FIRST LEVEL - FLOOR PLAN

FLOOR PLAN - FIRST LEVEL
3/32" = 1'-0"

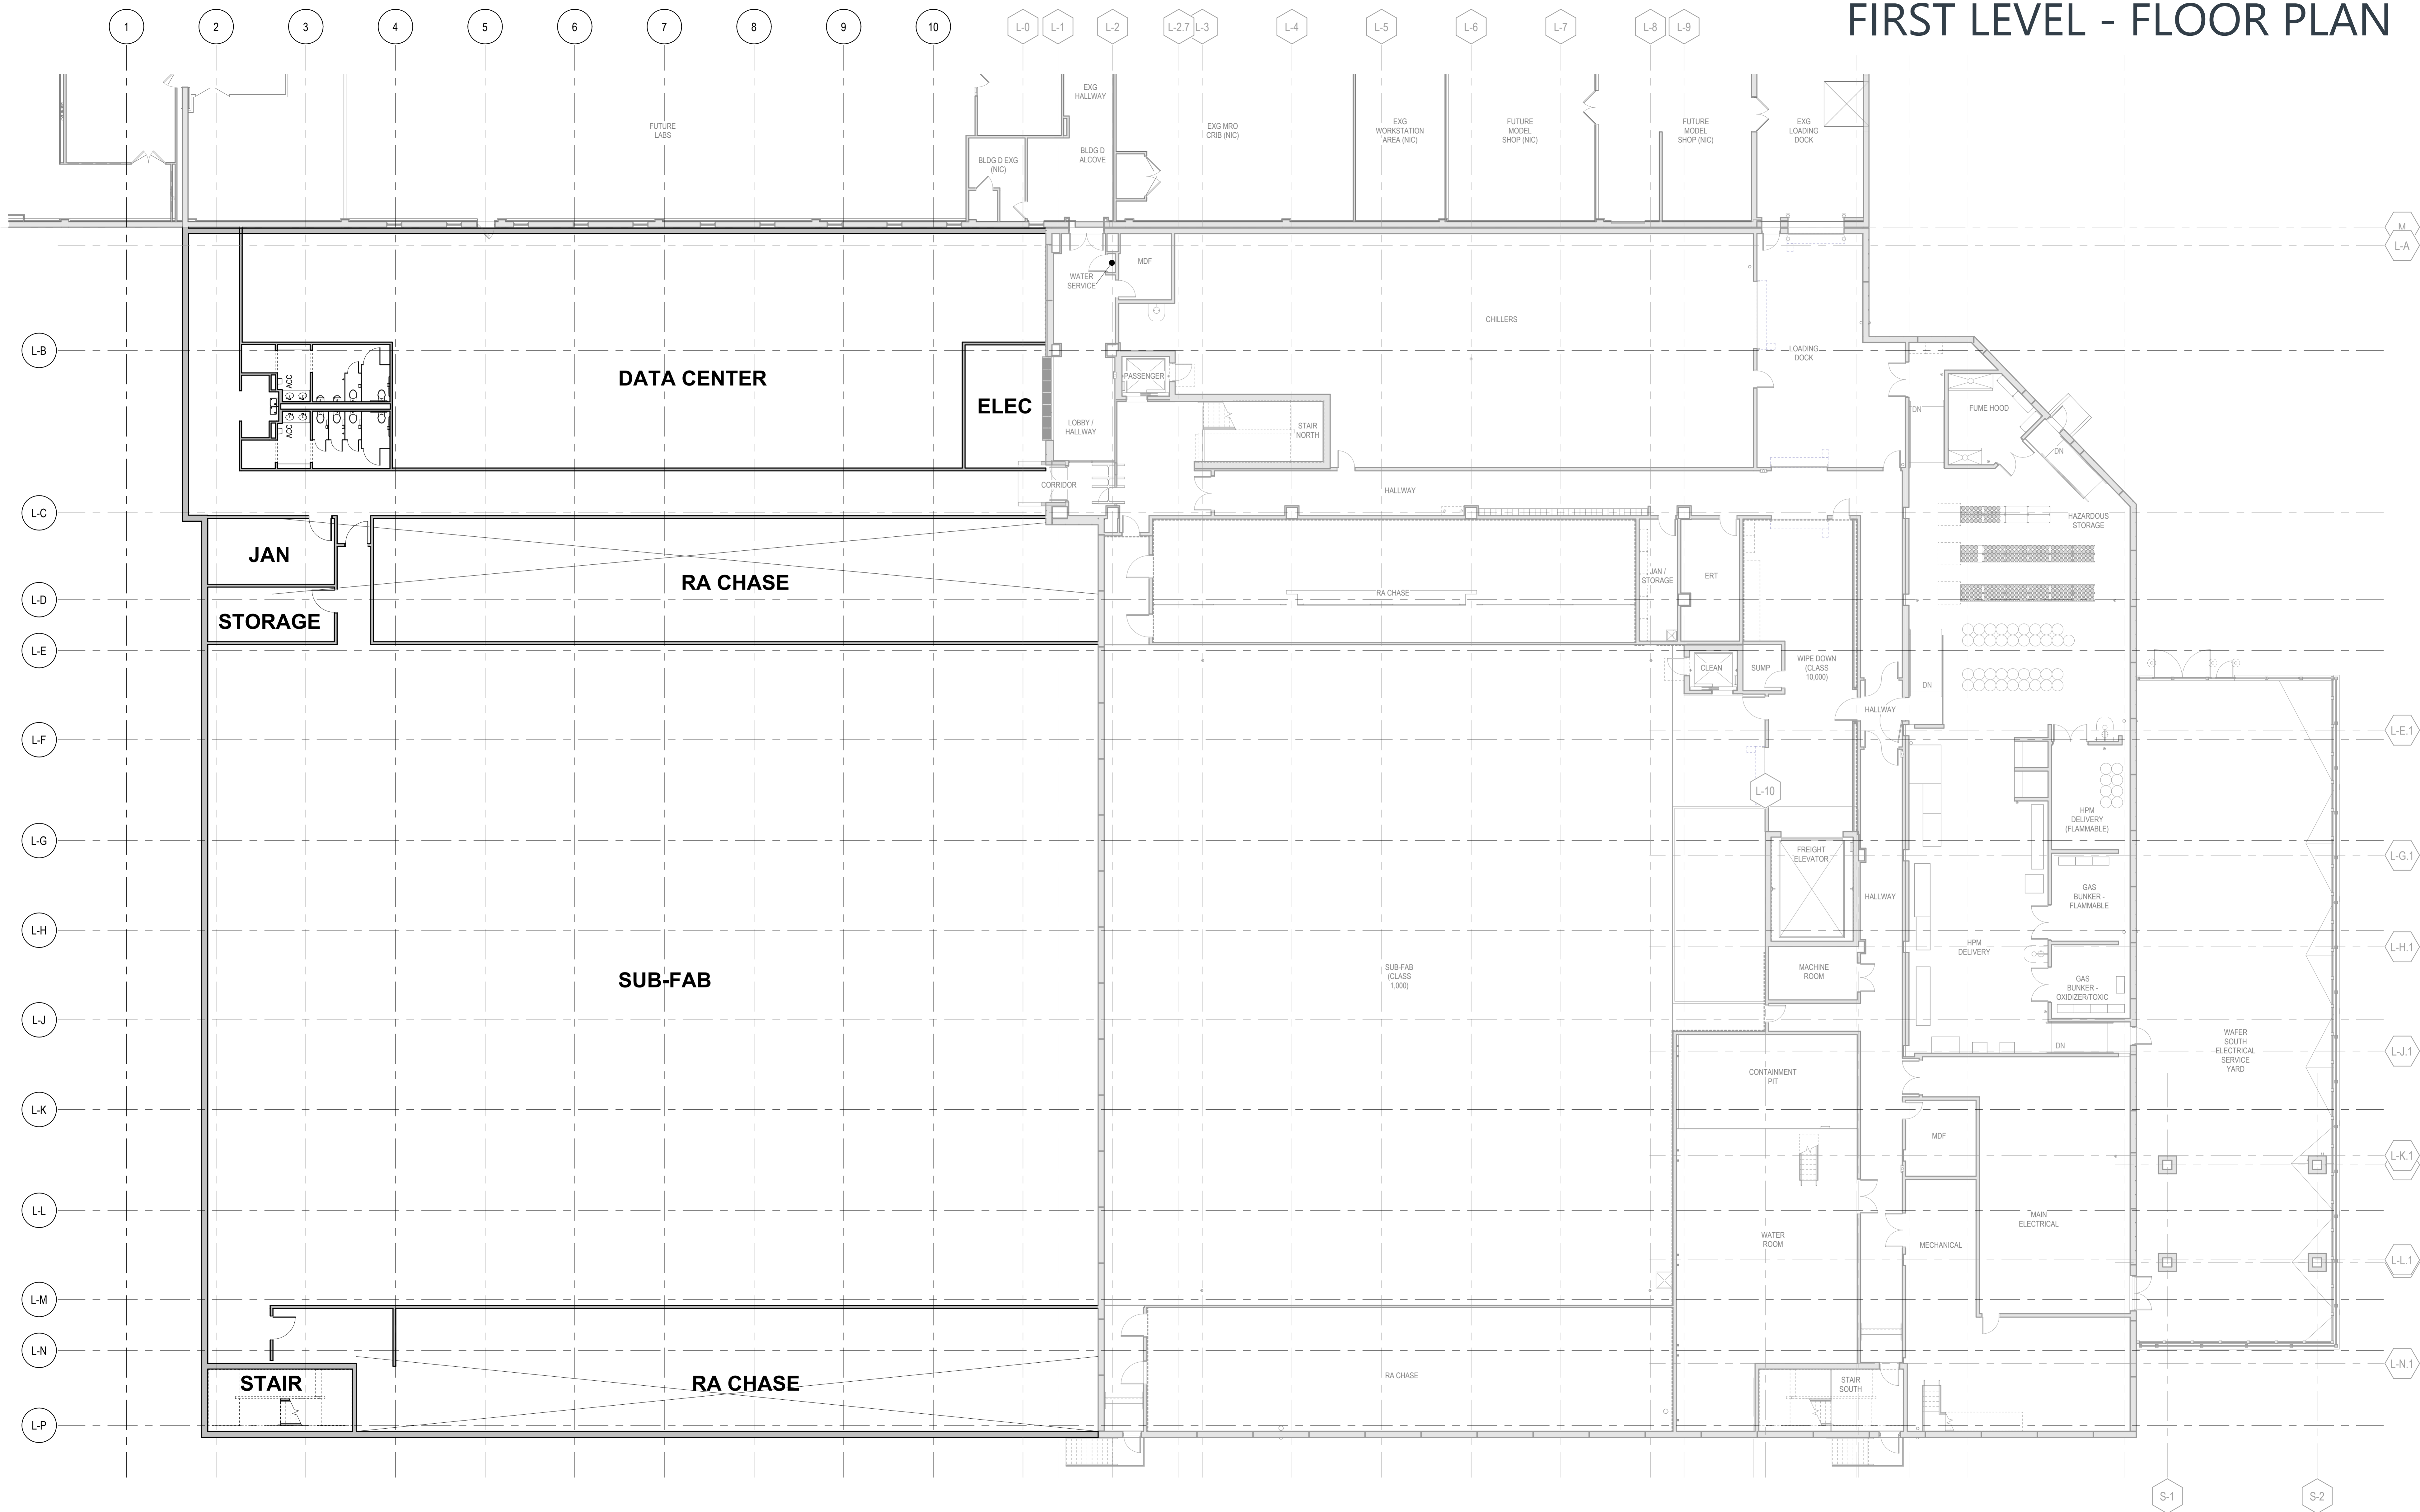
Must meet 2020 MN State Building Code	Provide a detailed code analysis with the plans.
Must meet 2020 MN Accessibility Code.	When plans are 80% complete please contact Building & Inspections to set up a Building Code review.
Building plans must be signed by a MN licensed architect.	A report shall be submitted identifying the maximum expected quantities of Hazardous Materials. The report shall be prepared by a qualified person, firm, or corporation.
SAC review by MET Council will be required. On January 2nd, 2025, the City of Bloomington implemented a City SAC charge. The cost will be \$2,020 per City SAC unit. The amount of SAC charged will mirror the MET Council Determination. This applies to any permits submitted on or after 01/02/25.

SECOND LEVEL - FLOOR PLAN

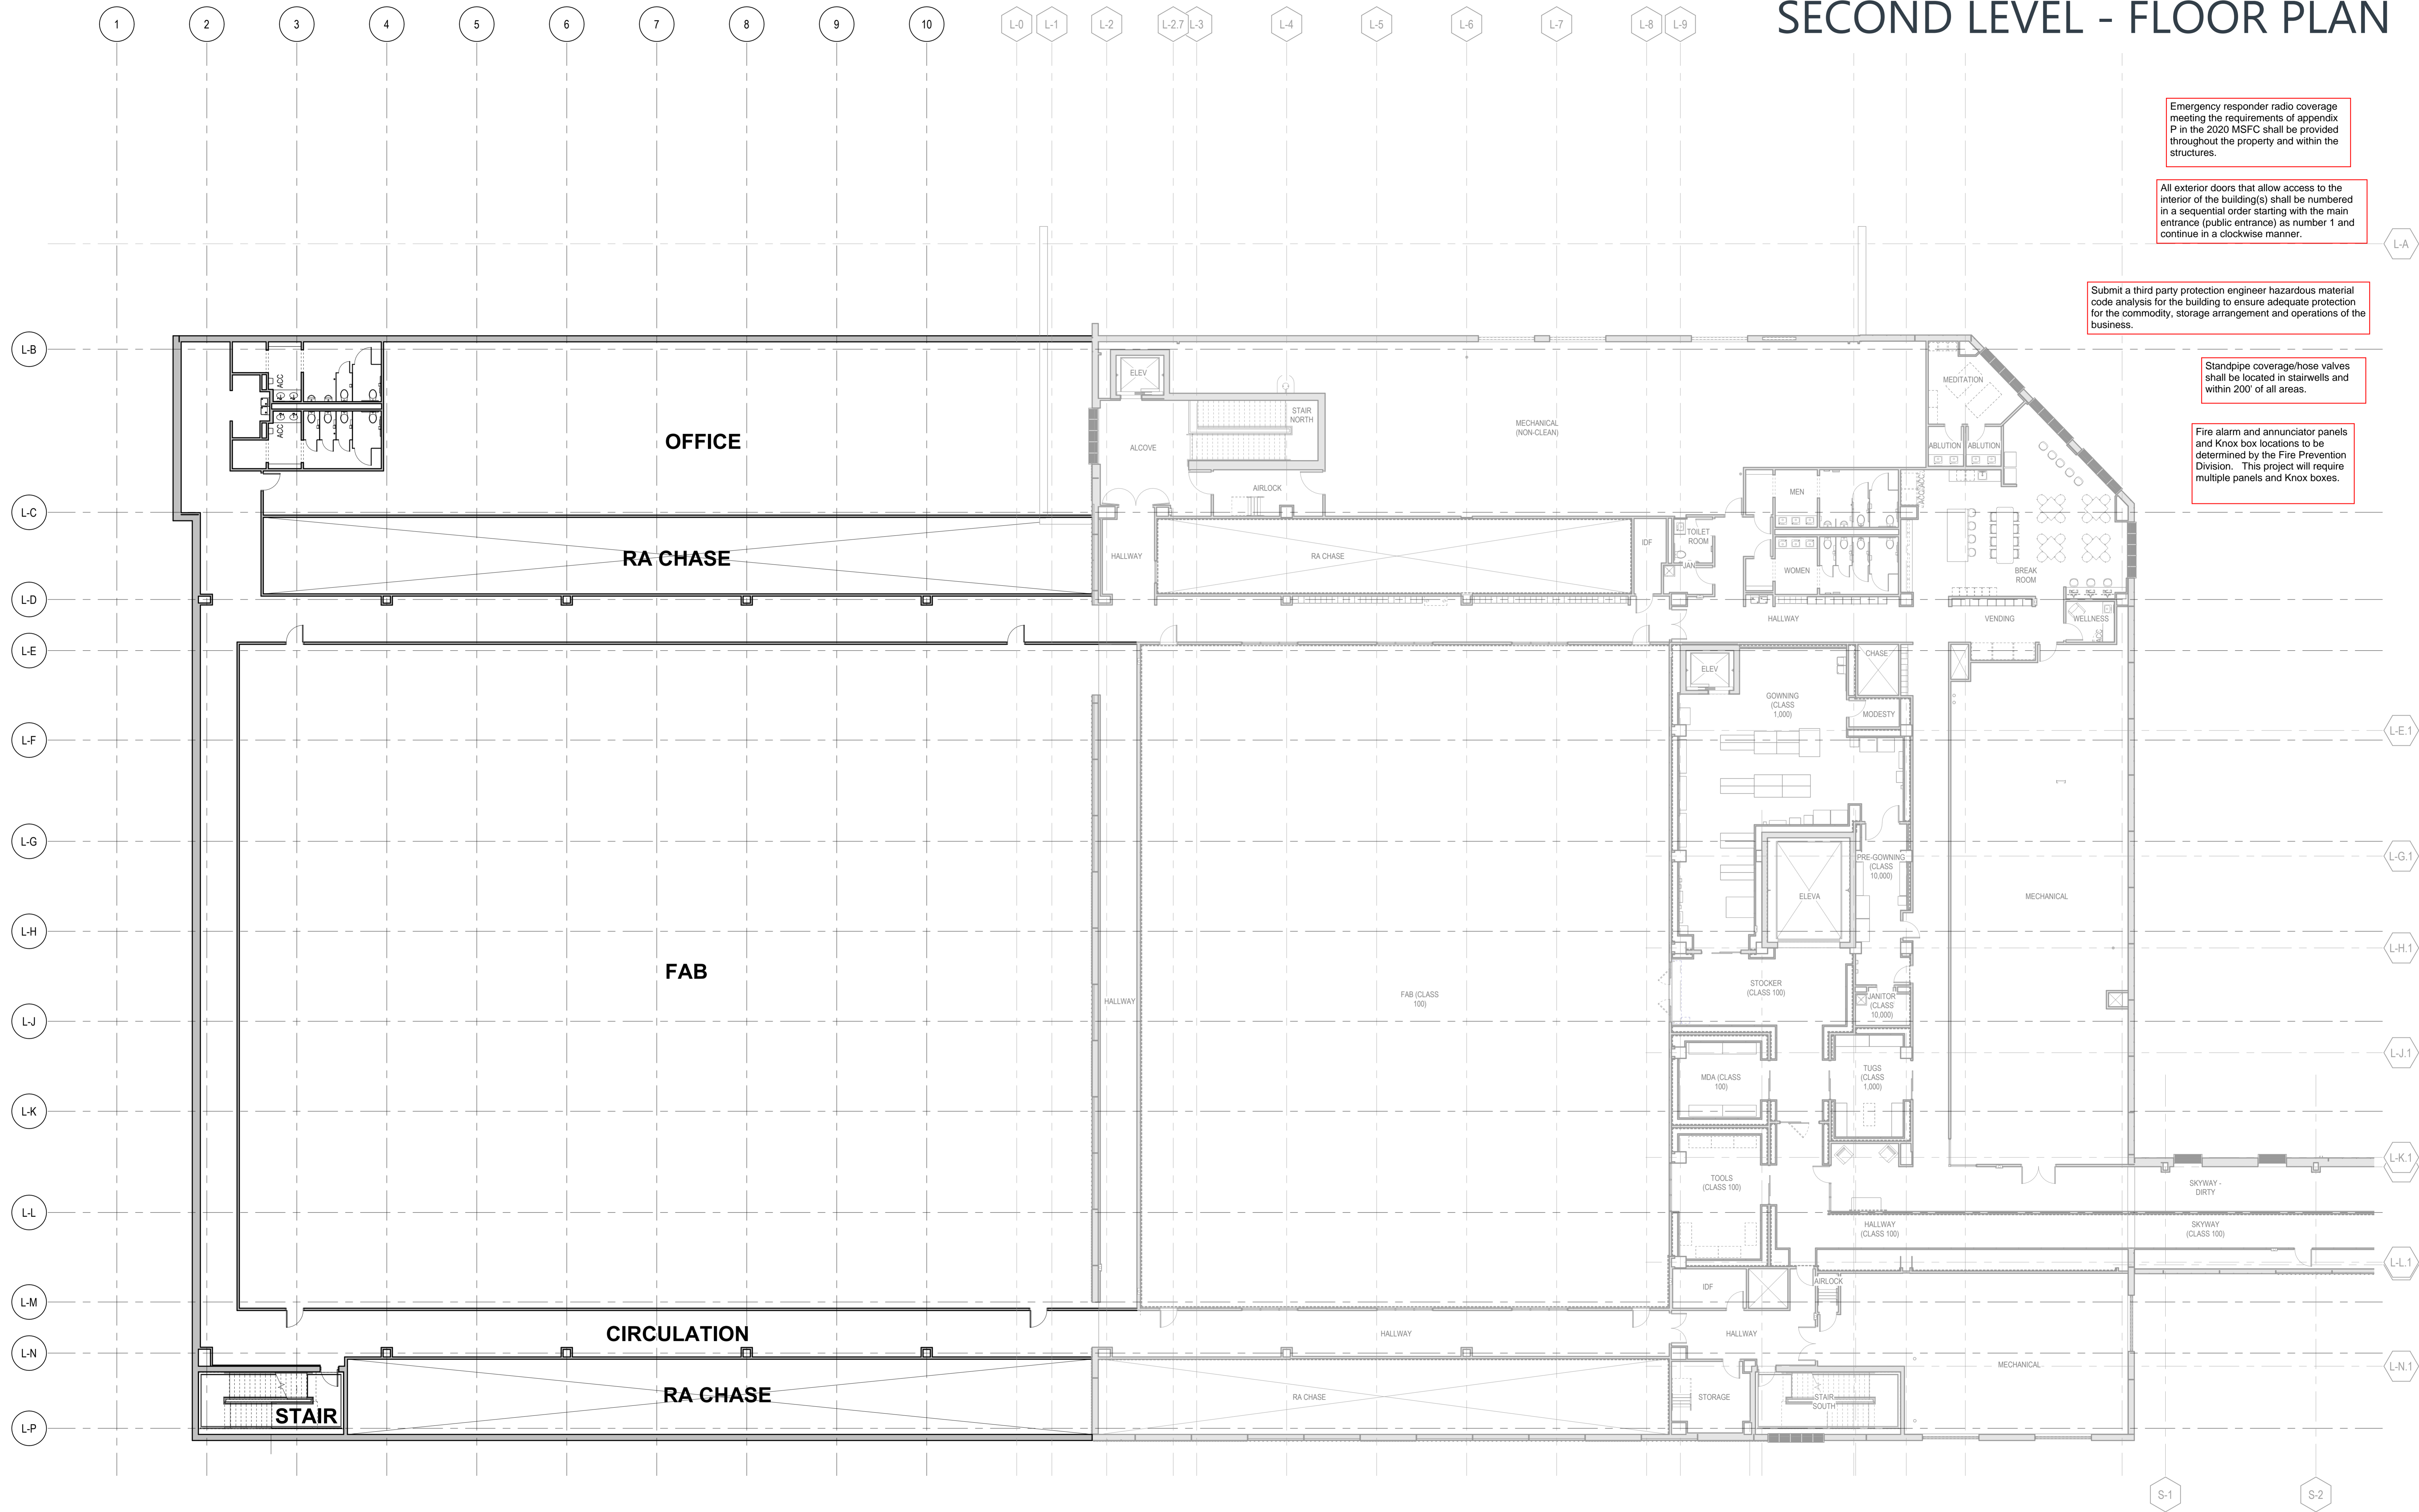
Emergency responder radio coverage meeting the requirements of appendix P in the 2020 MSFC shall be provided throughout the property and within the structures.

All exterior doors that allow access to the interior of the building(s) shall be numbered in a sequential order starting with the main entrance (public entrance) as number 1 and continue in a clockwise manner.

Submit a third party protection engineer hazardous material code analysis for the building to ensure adequate protection for the commodity, storage arrangement and operations of the business.

Standpipe coverage/hose valves shall be located in stairwells and within 200' of all areas.

Fire alarm and annunciator panels and Knox box locations to be determined by the Fire Prevention Division. This project will require multiple panels and Knox boxes.
